TRAFFIC AND PARKING IMPACT ASSESSMENT OF A RESOURCE RECOVERY FACILITY

344 Park Road-Wallacia

Traffic and Parking Impact Report

19m SEMI TRAILER VEHICLE SWEEP PATH PLAN
HEAVY VEHICLE MANOEUVRING WITHIN
INTERSECTION OF GREENDALE ROAD / PARK ROAD
PROPOSED RESOURCE RECOVERY FACILITY
344 PARK ROAD, WALLACIA

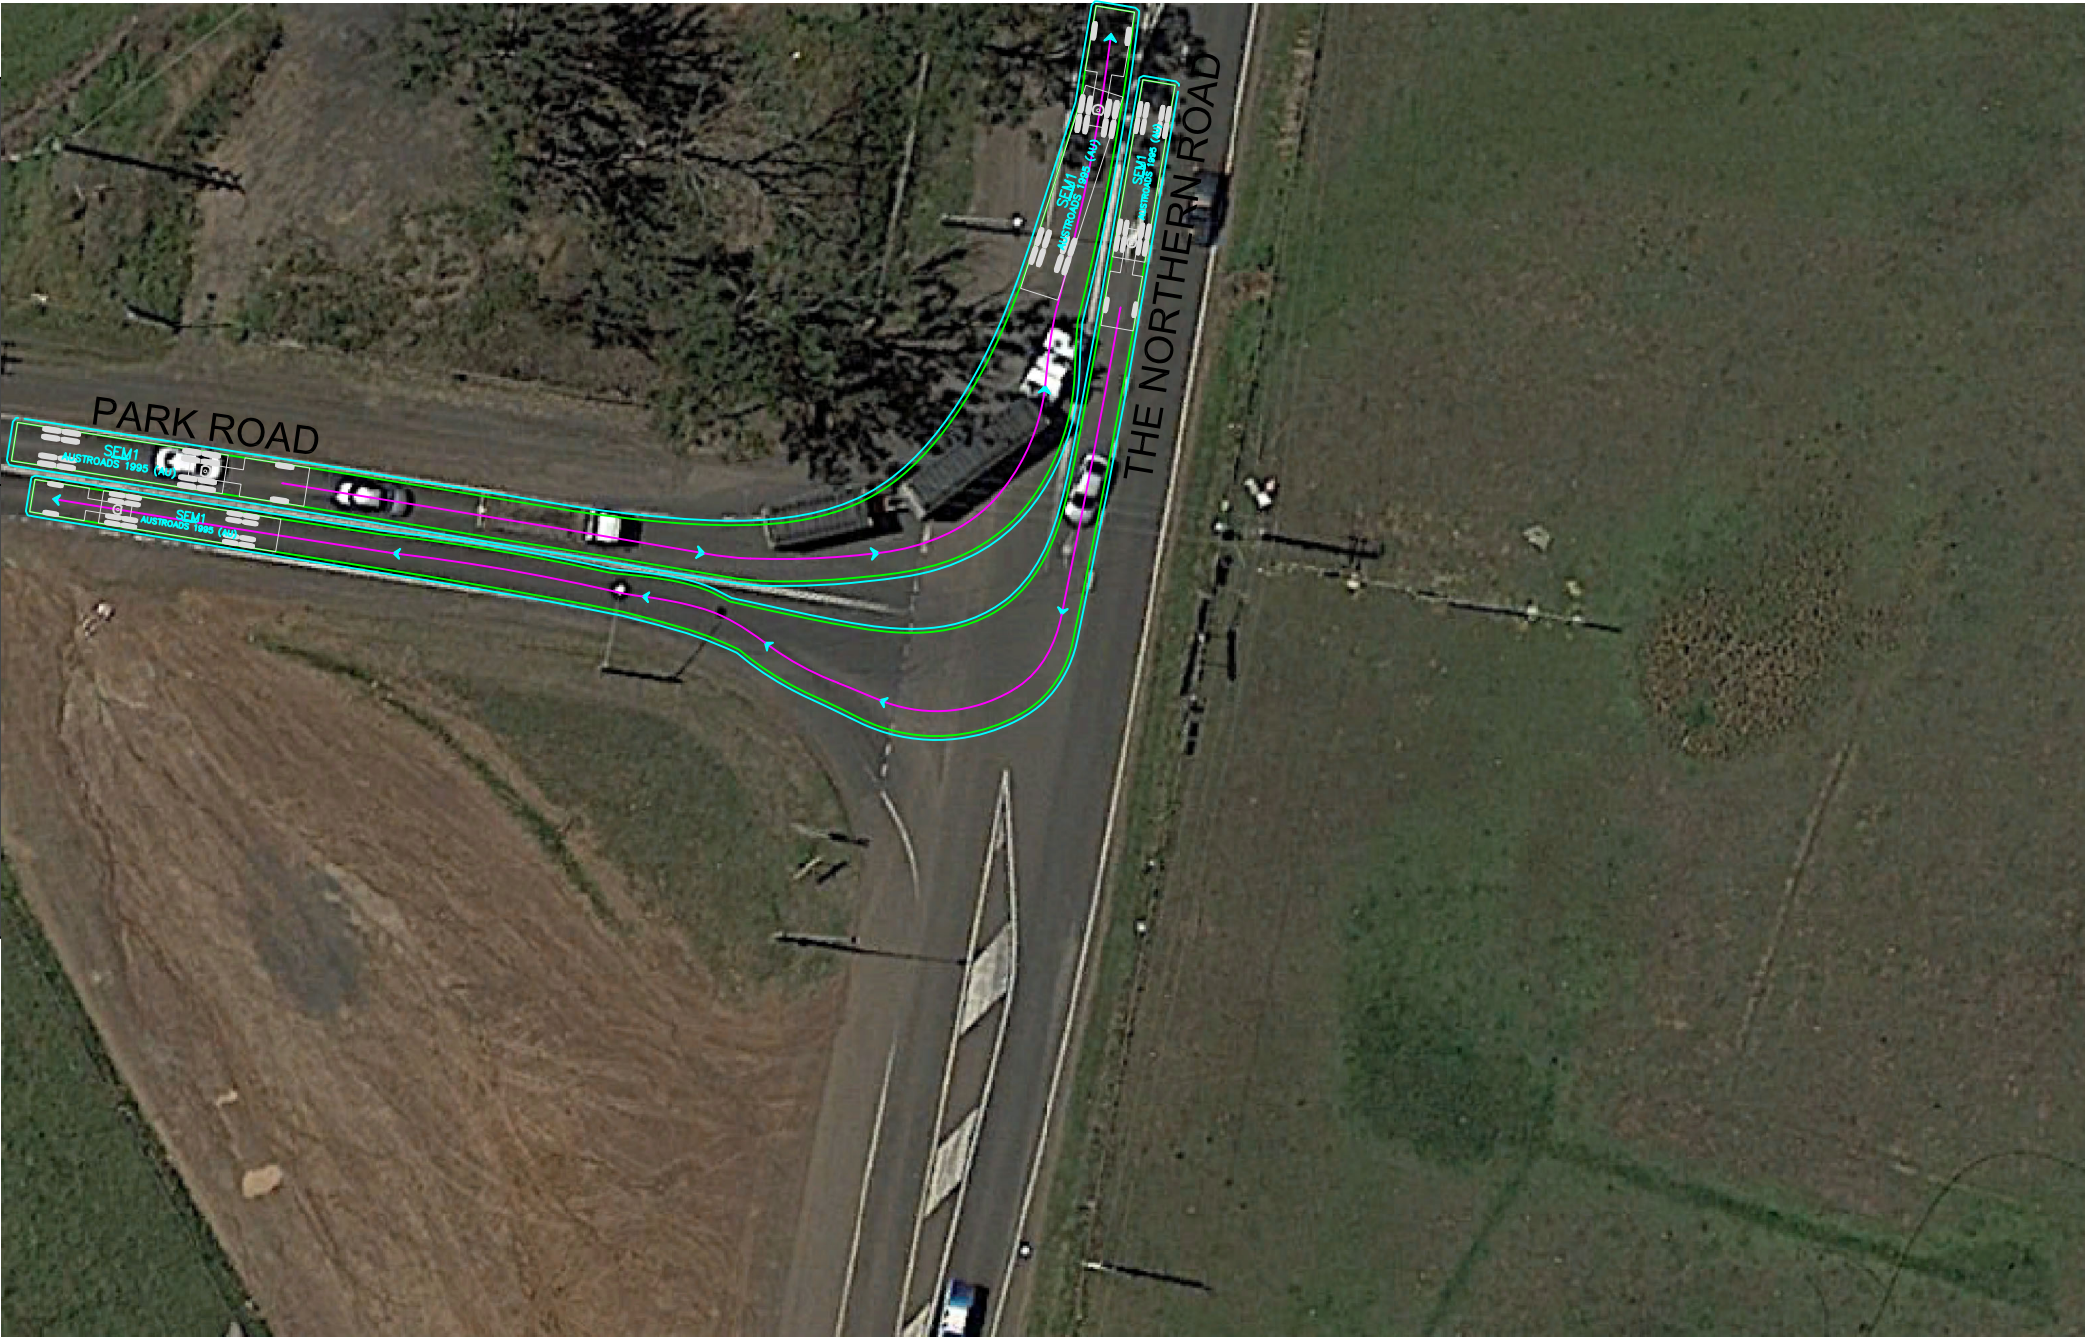
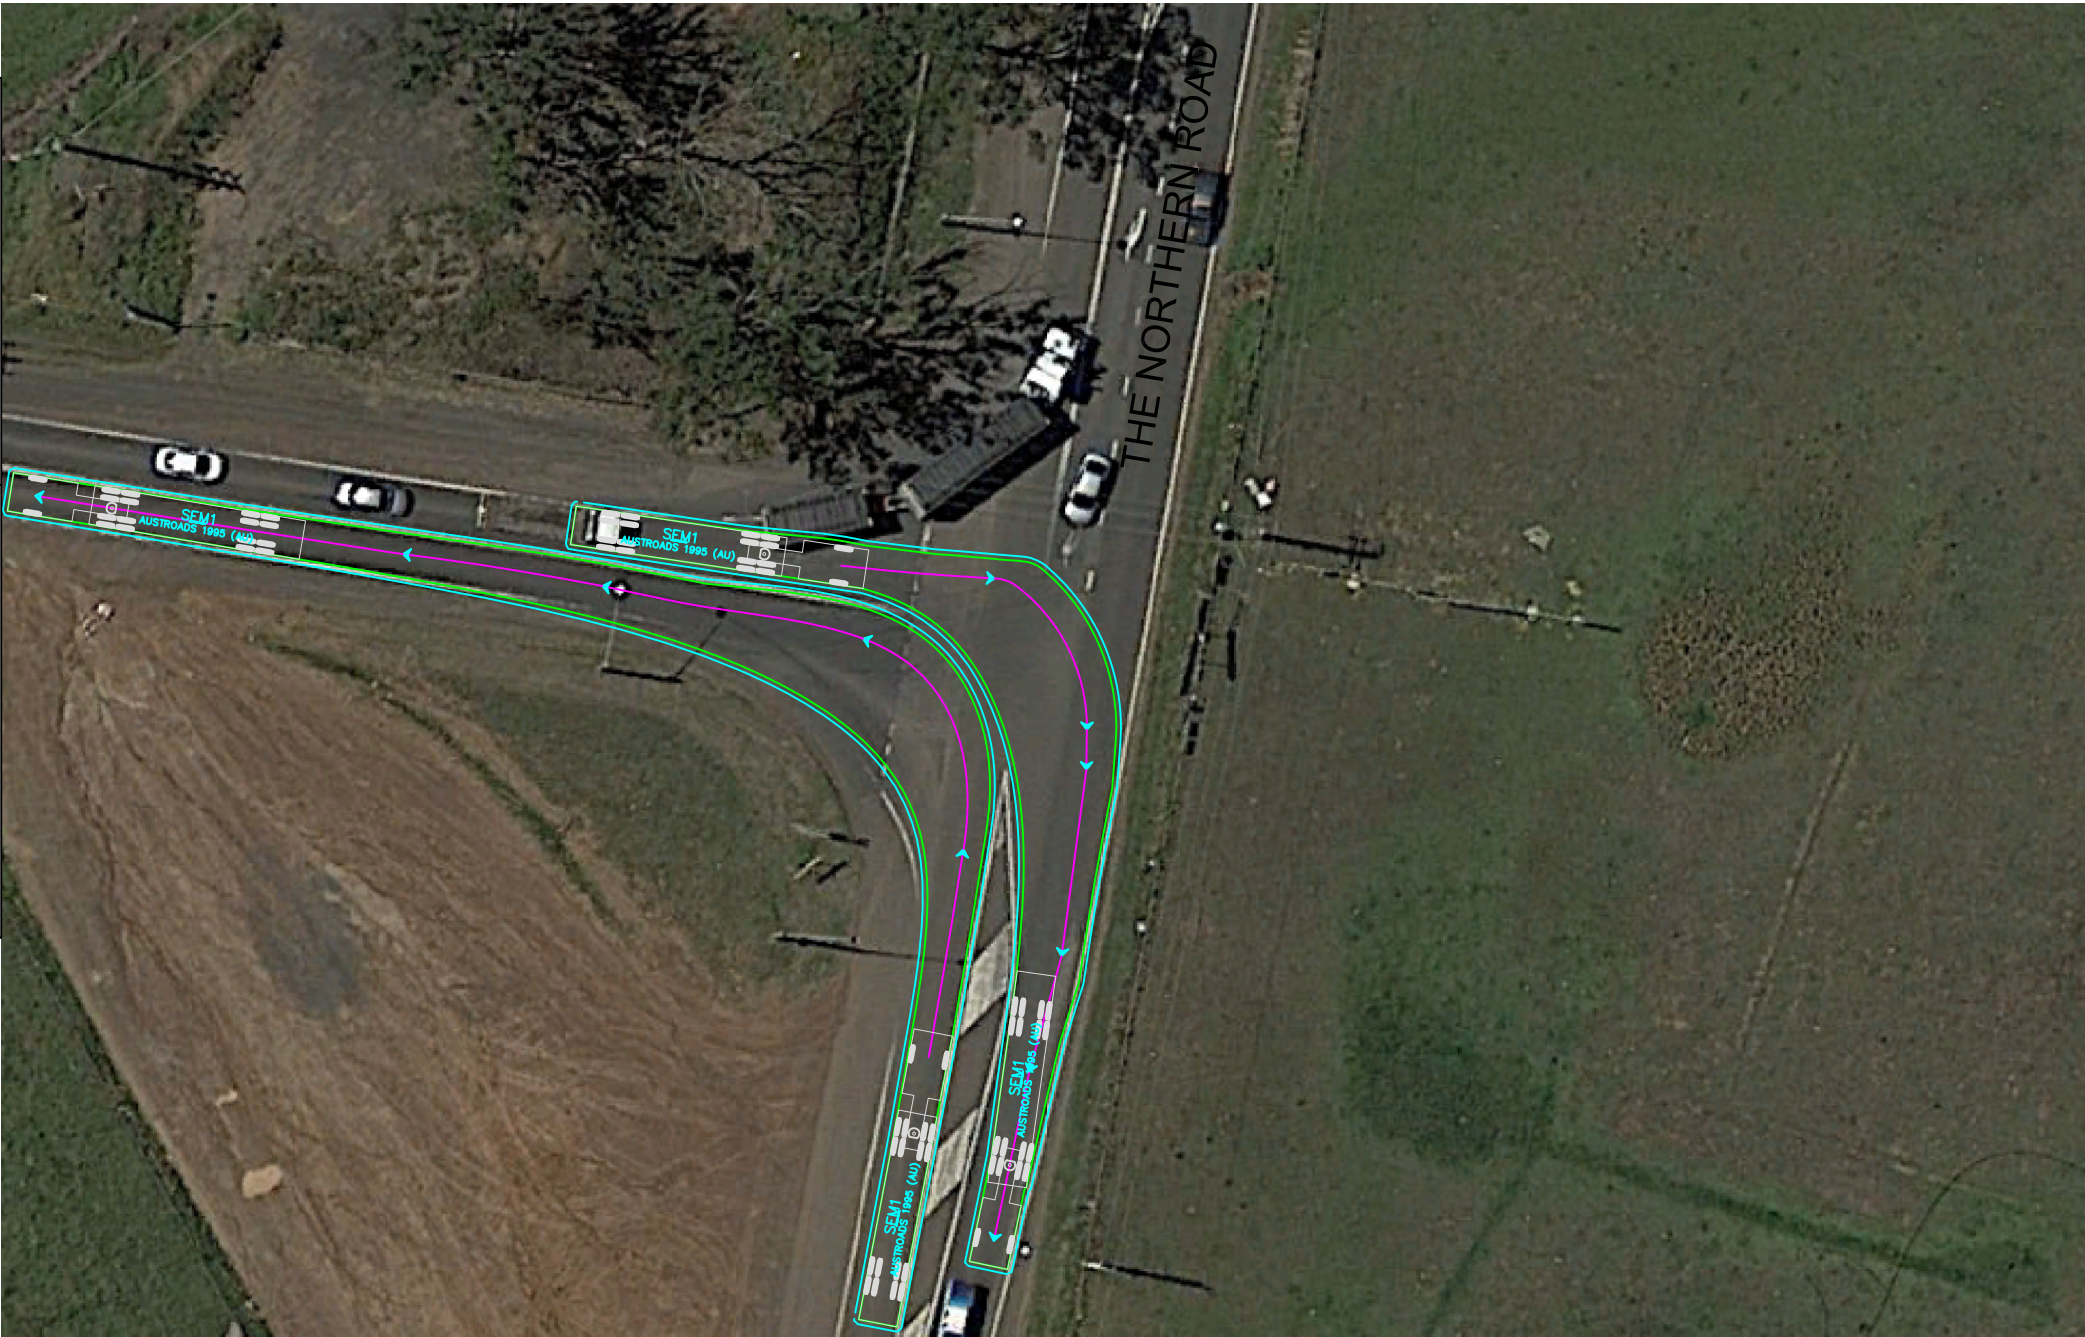
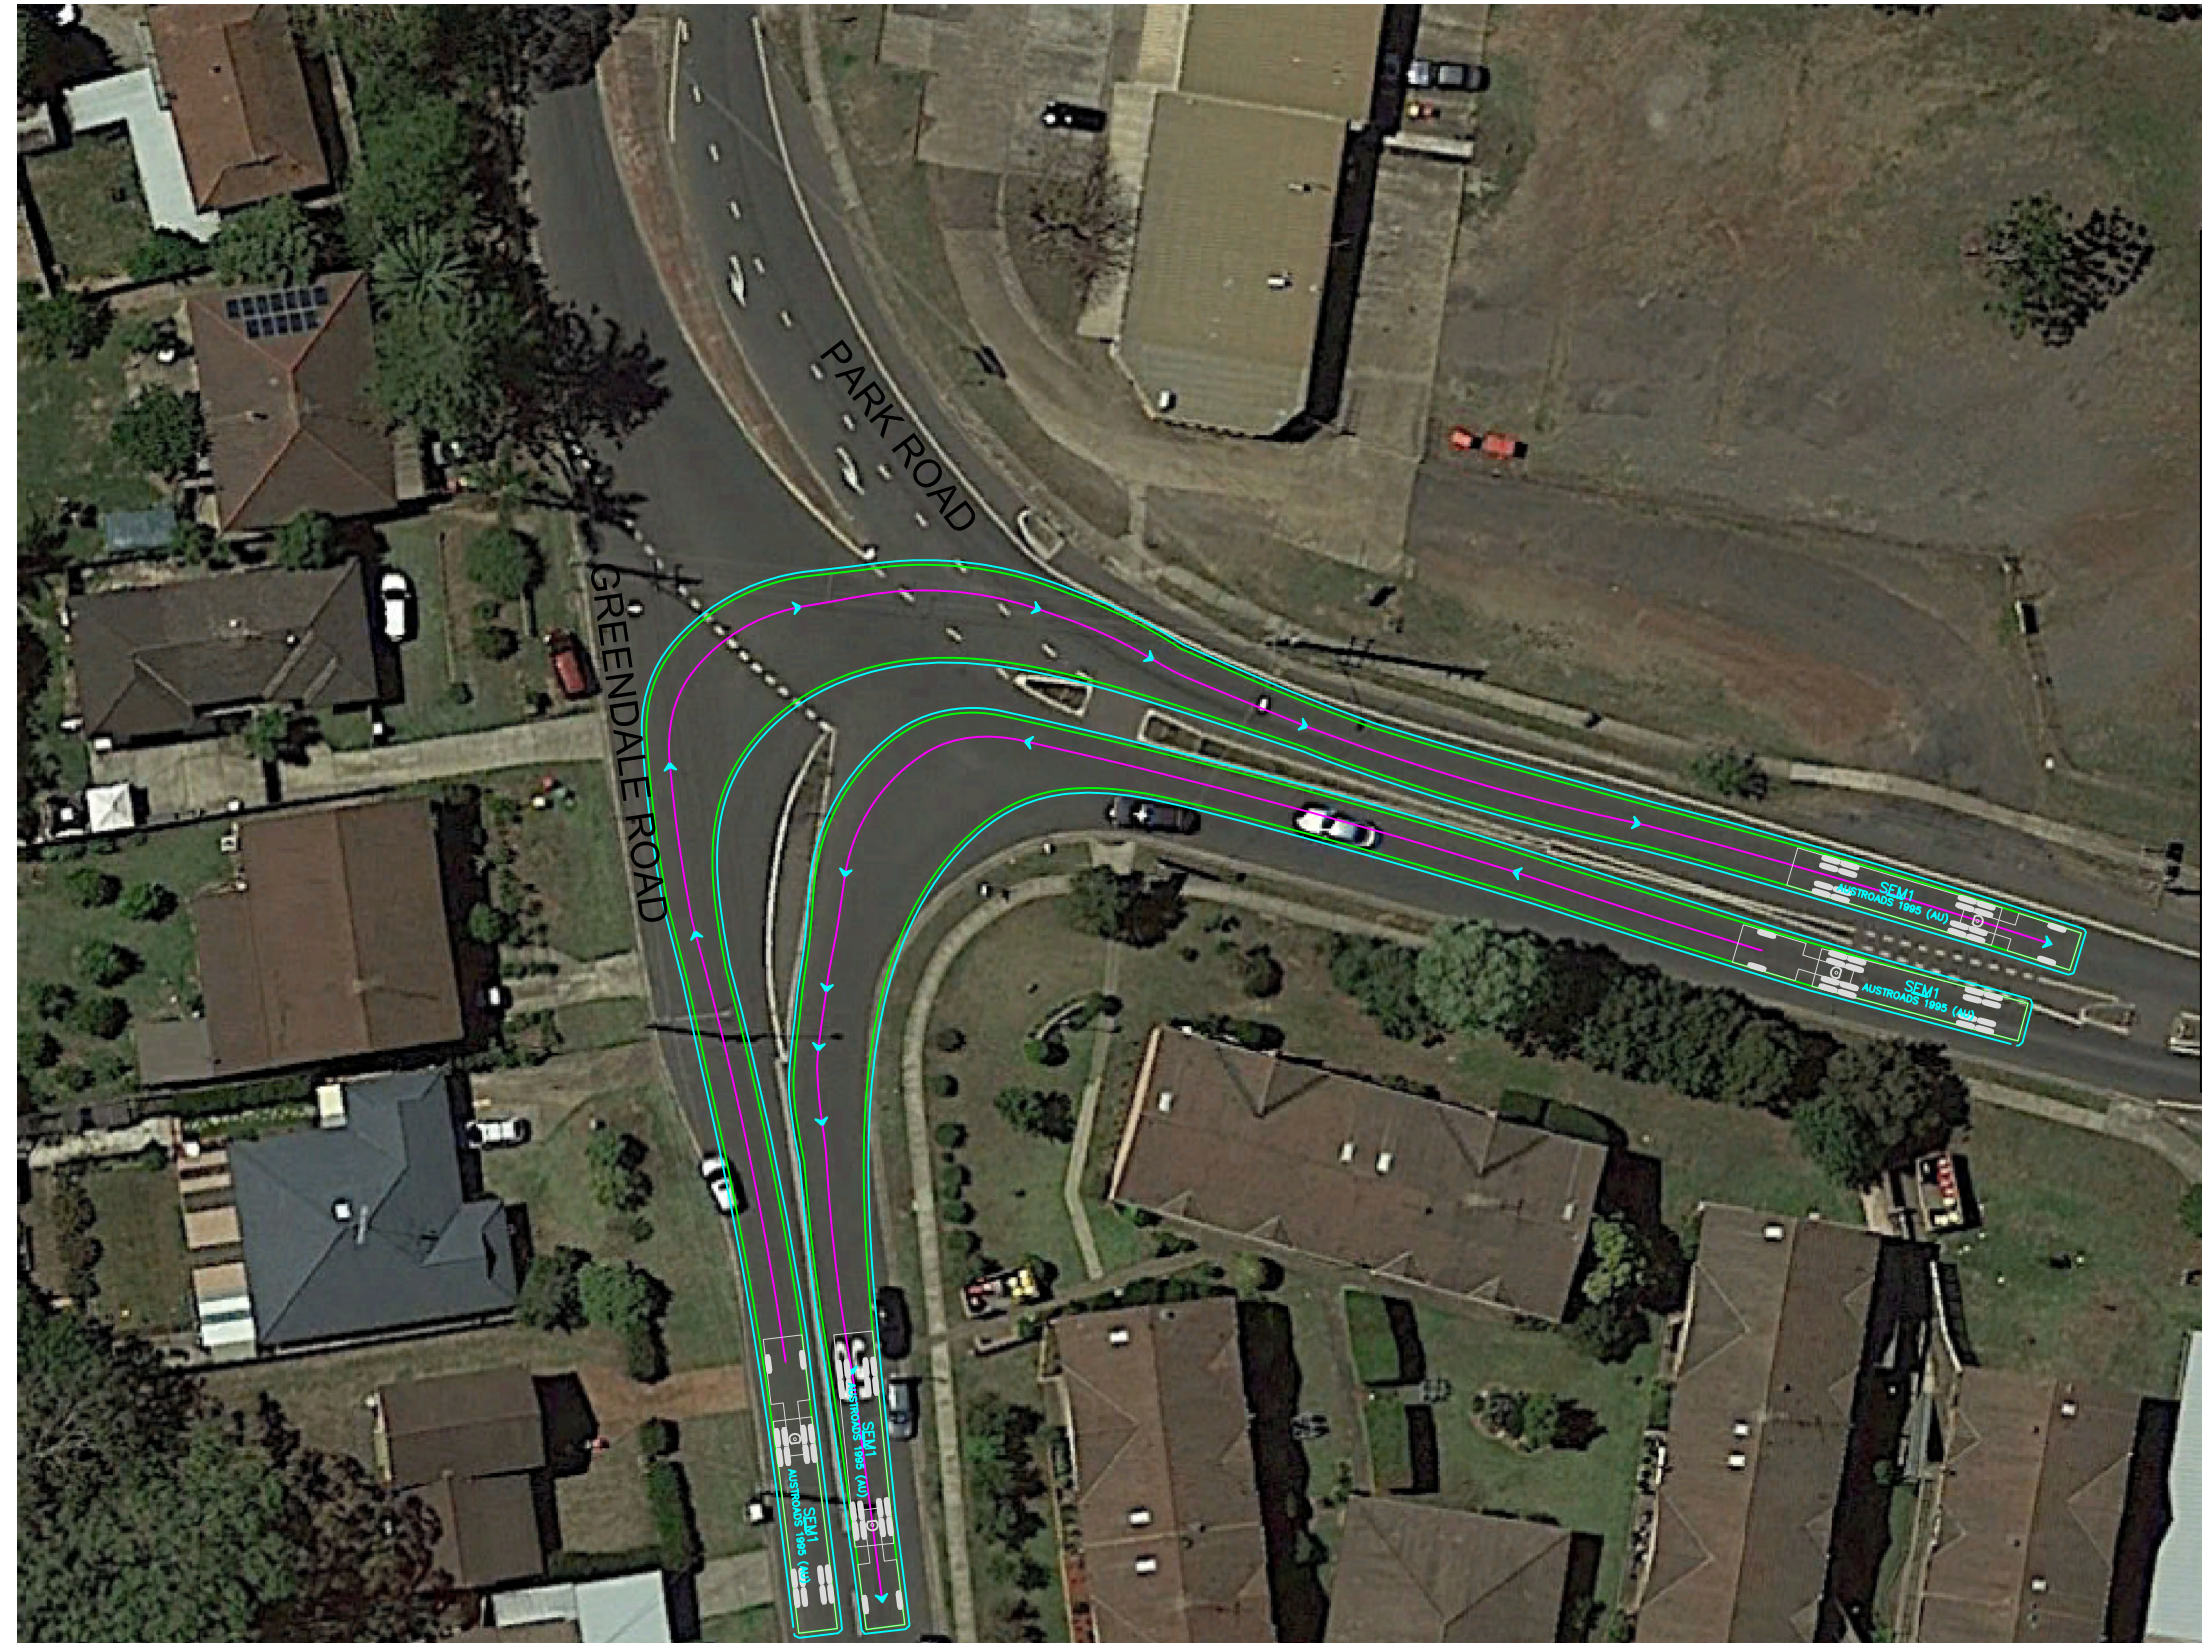
5. *The swept path plans provided for the largest vehicle for the two key intersections – Park Road / The Northern Road and Park Road / Greendale Road are not satisfactory. The paths should be a smooth, single radius and not have a kink as currently demonstrated. Please provide amended plans demonstrating the swept paths in a smooth, single radius.*

In order to assess the suitability of 19m long semi-trailer vehicles to negotiate the intersections of Park Road / The Northern Road and Park Road / Greendale Road, a series of swept path plans have been prepared and are attached as **Appendix 4** for reference. These swept path plans have been generated utilising aerial images as a base and illustrate the following:
